HISTORIC DISTRICT COMMISSION

CERTIFICATE OF APPROPRIATENESS

Application Number: HDC2025-00065

HISTORIC DISTRICT COMMISSION ADDITIONAL INFORMATION REQUEST

Elevations
Window Schedule

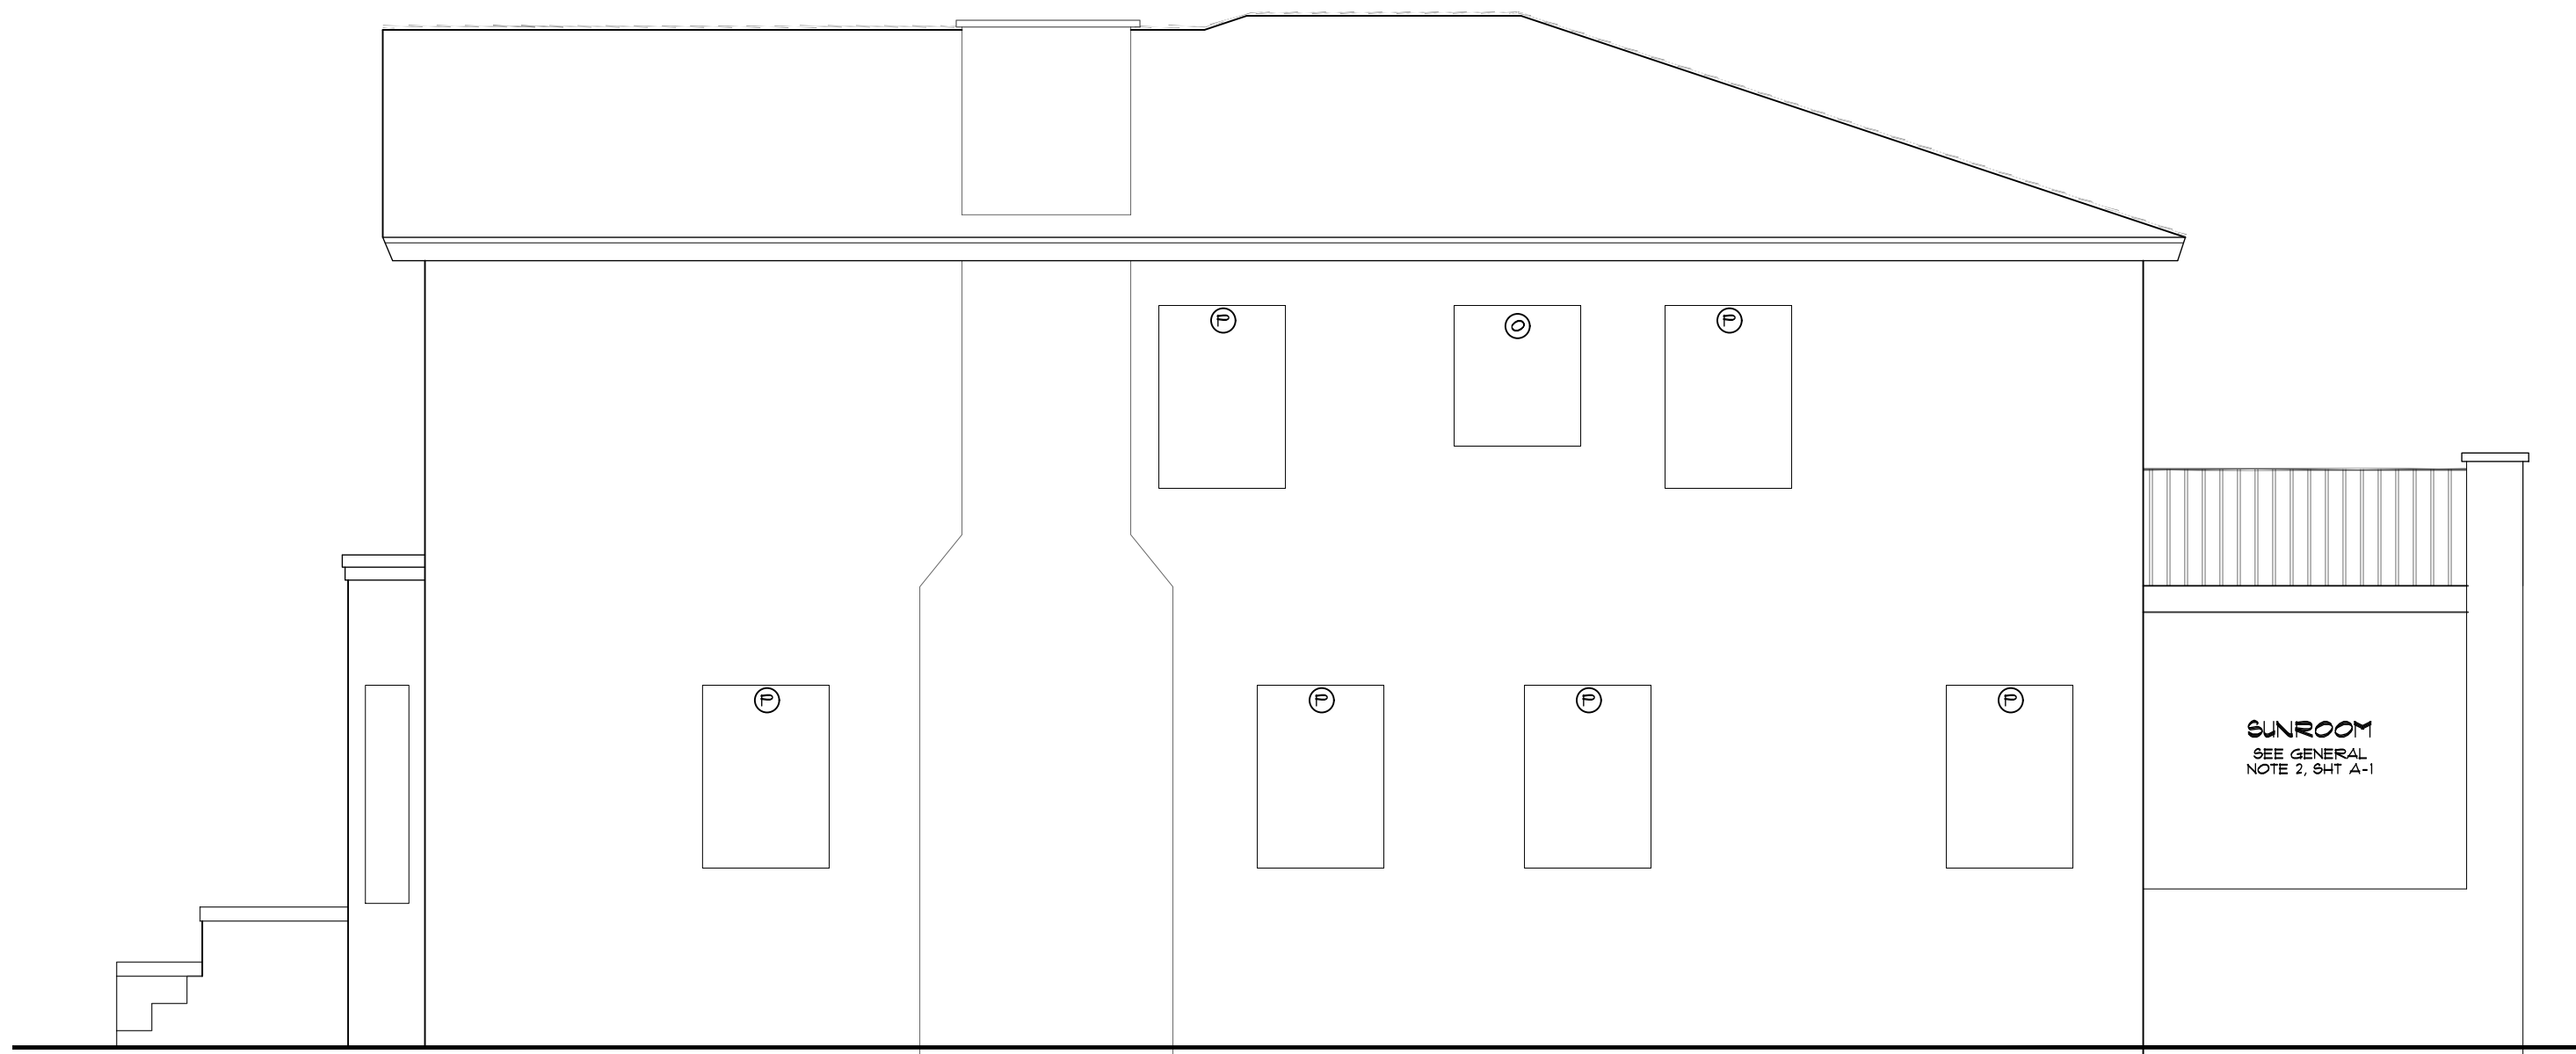
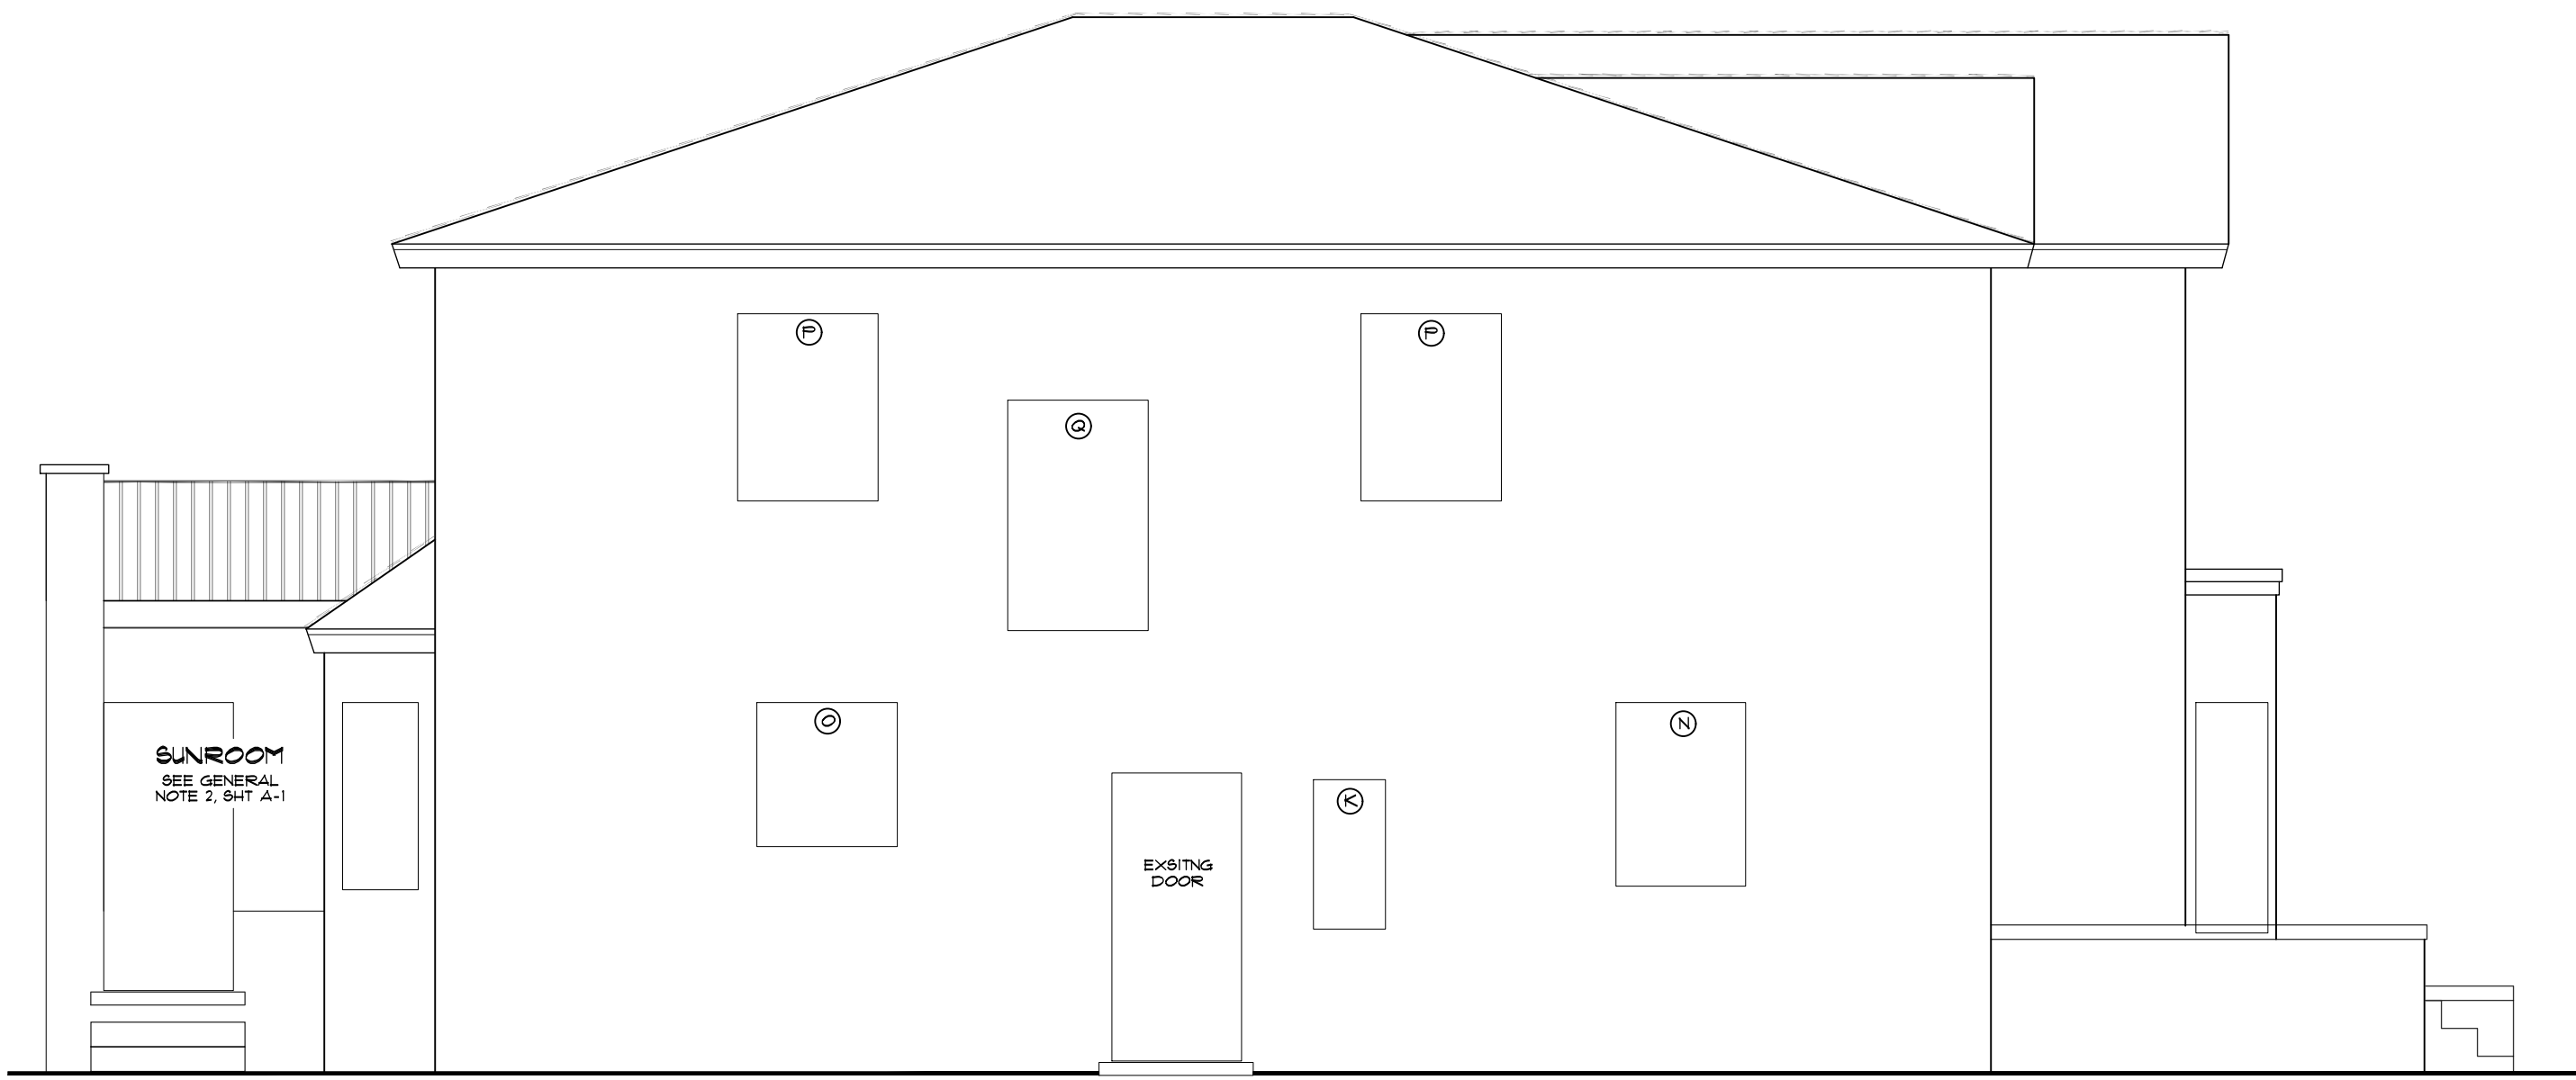
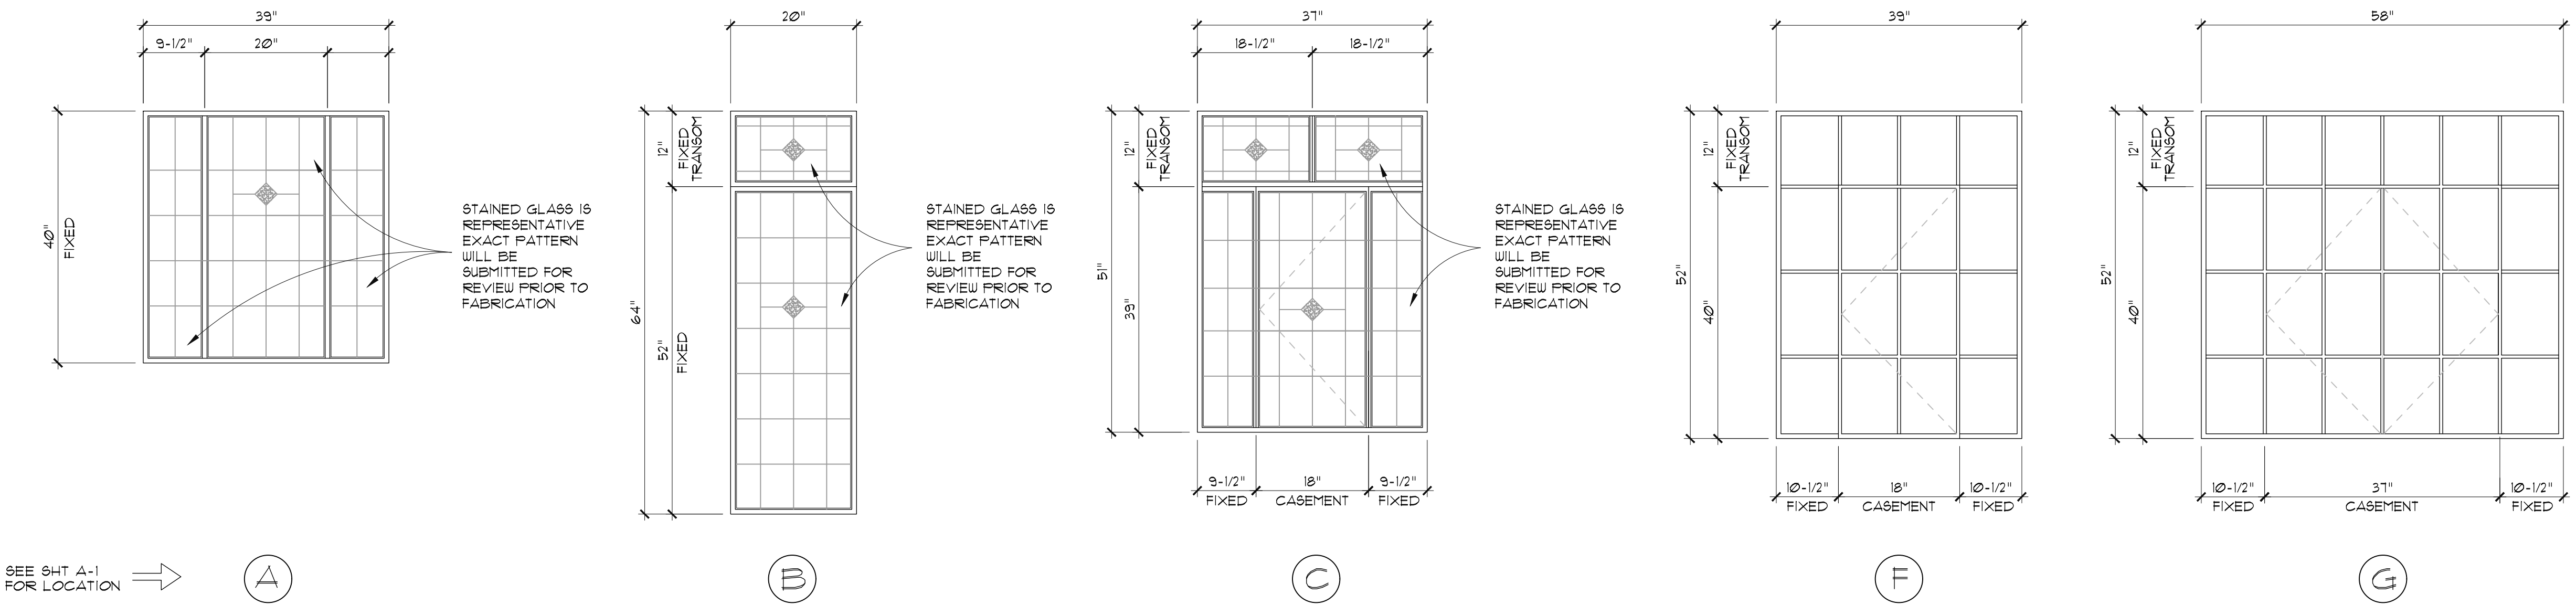
For the new steel windows at the front facade -

- a more detailed window schedule, which can be achieved:

The generation of a dimensioned elevation drawing of the front facade which shows the new windows, calling out their material, operation, and light configuration -OR- you can present window schedule/the information for each window opening at the front facade in a line-item format (which includes a sketch and specs per line/opening/window) as depicted in my attached document

This is the window schedule drawings as requested.

PROPOSED STEEL WINDOW SECTION

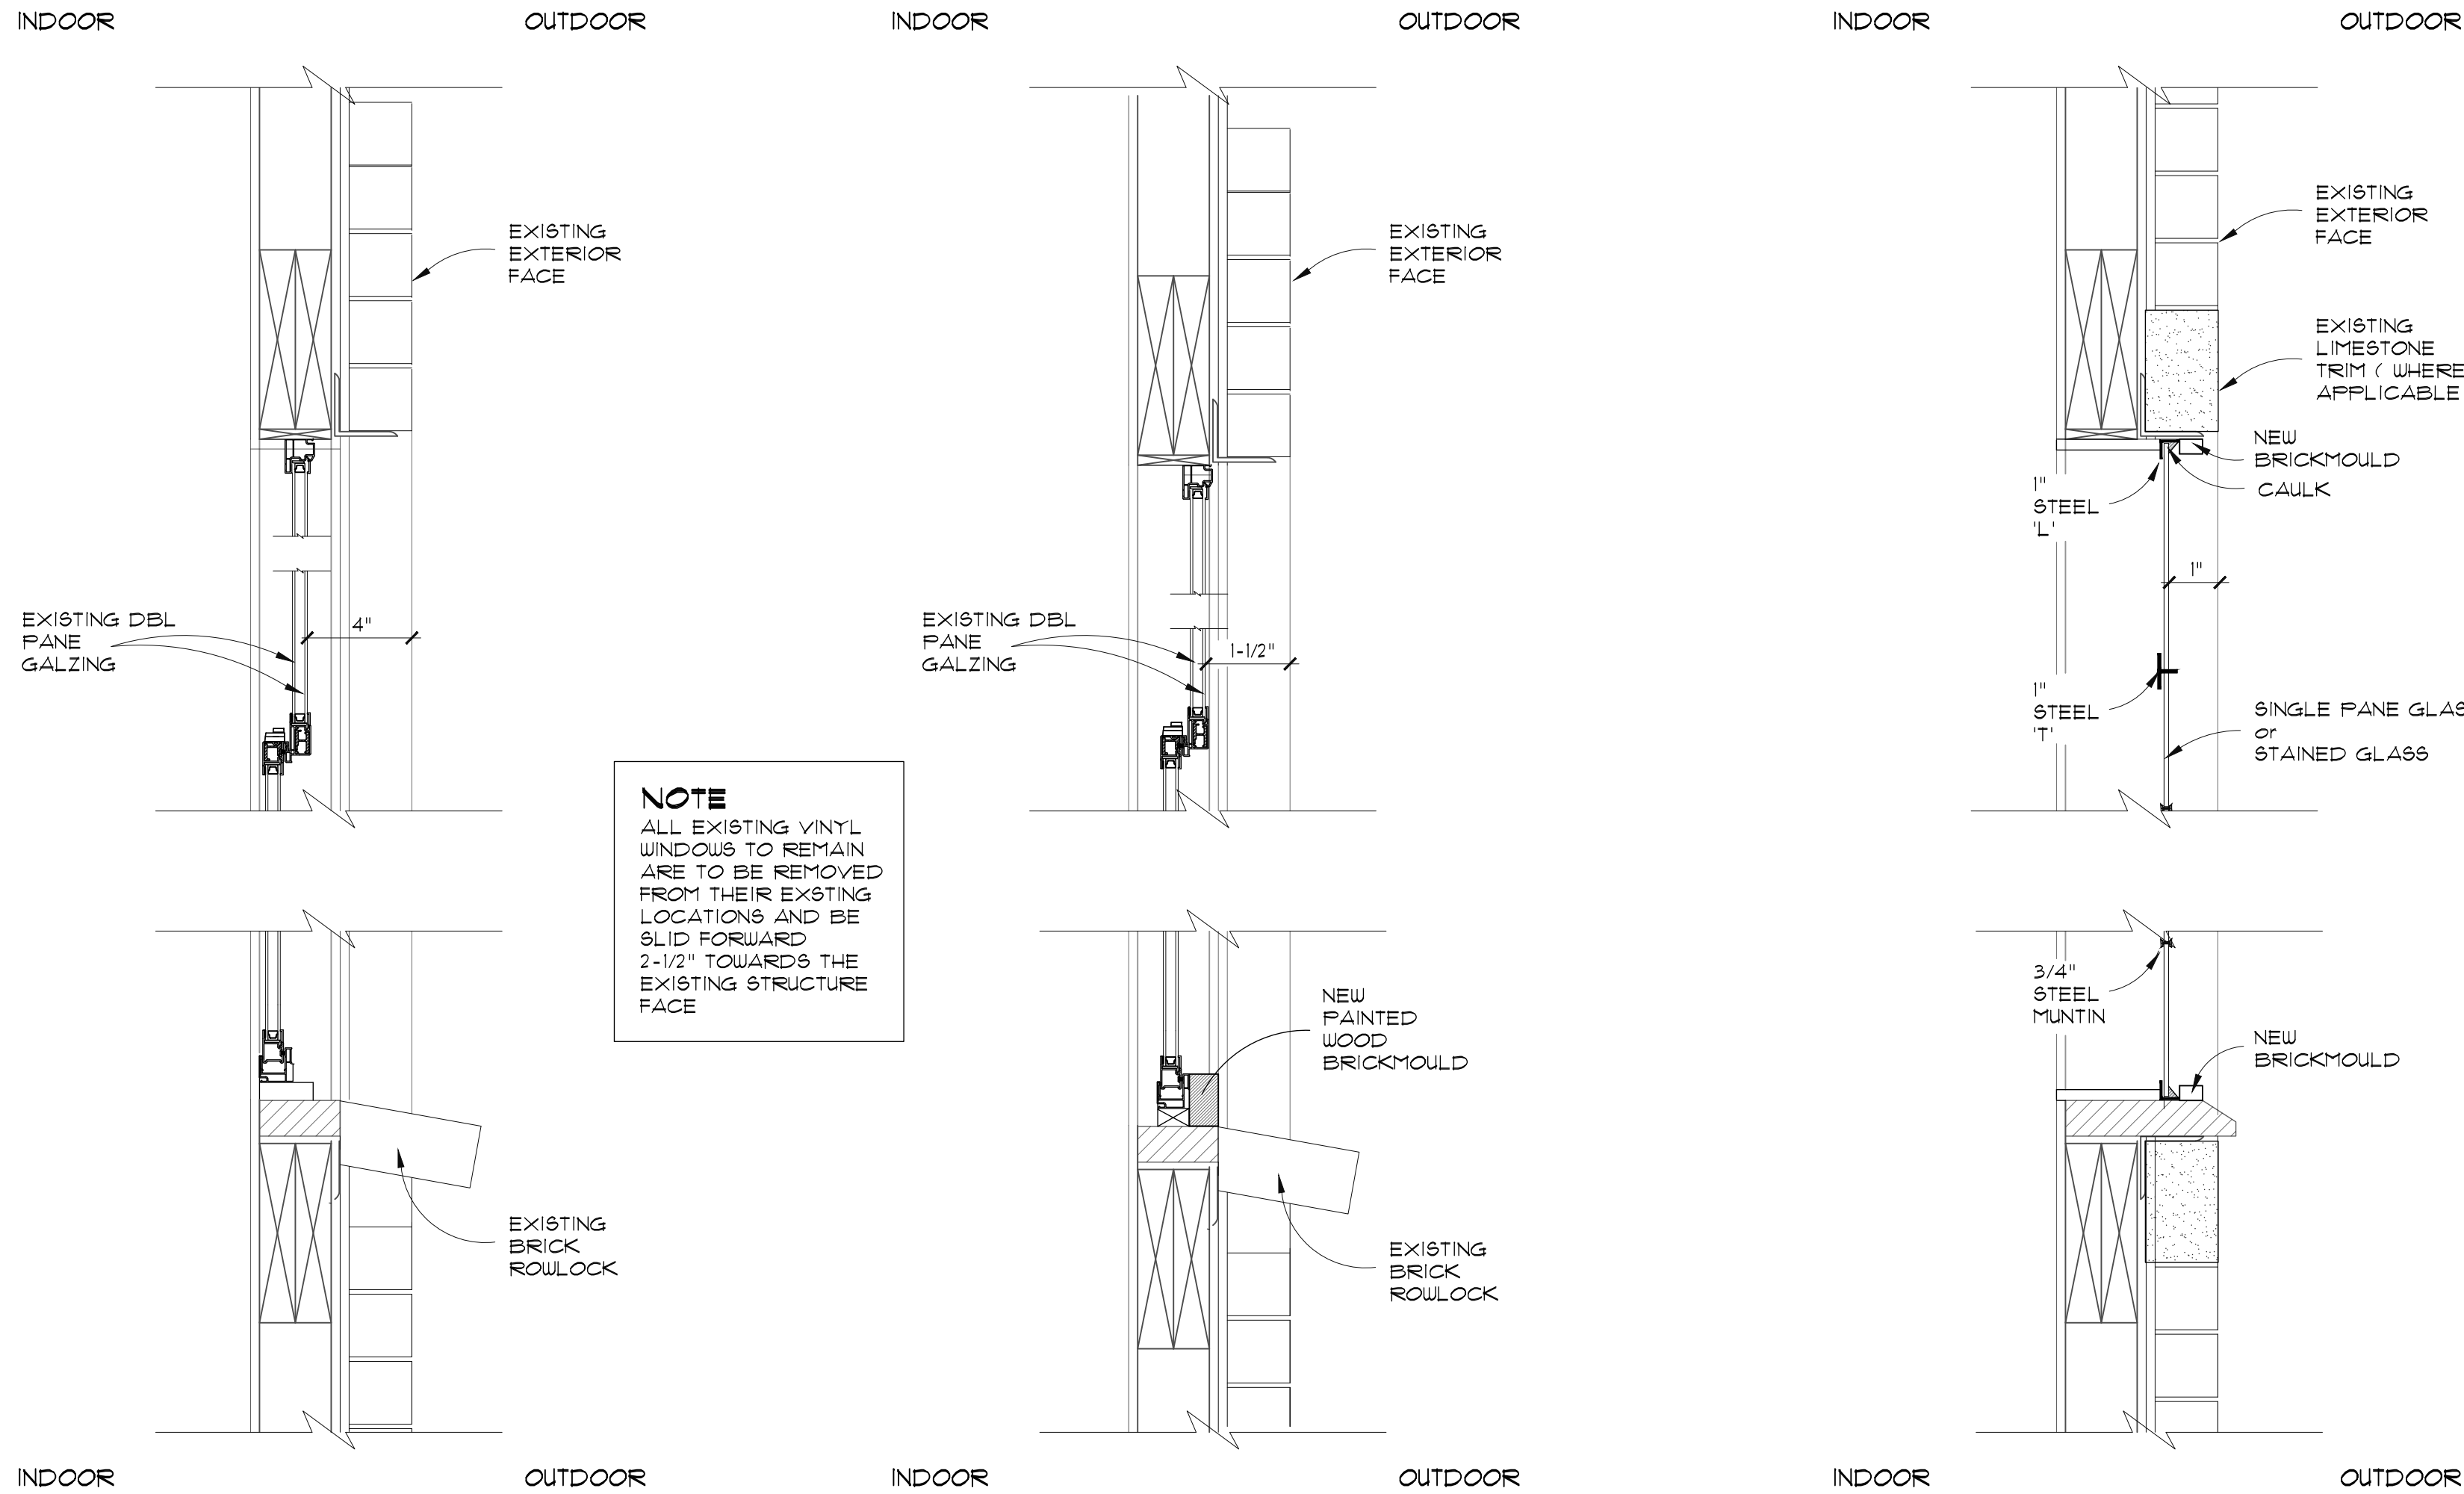
- dimensioned section drawings (vertical and horizontal) of the windows within the wall which show the typical profiles and dimensions at the muntins, meeting rails, sash, frames, and moldings. Since you indicate that these windows will be custom made/you do not have manufacturers' standard cut sheets, you will have to generate them. Note that they can hand drawn.
